Technical change: Optimization QR- Code on OMNIMATE POWER PCB Terminals

The marking of the QR- Code for the product families OMNIMATE Power PCB Terminals will be changed.
Please pass on this Product Change Notification (PCN) to your employees and, if applicable, to your customers.

Old QR- code		New QR- code

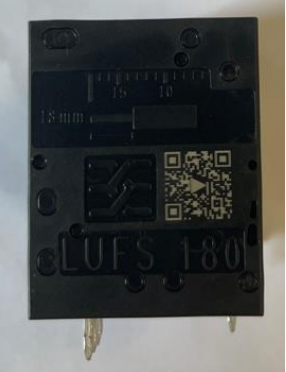
For the product families of power PCB Terminals (see article list for details), the QR codes will be printed directly on the Terminal in future and no longer a label.
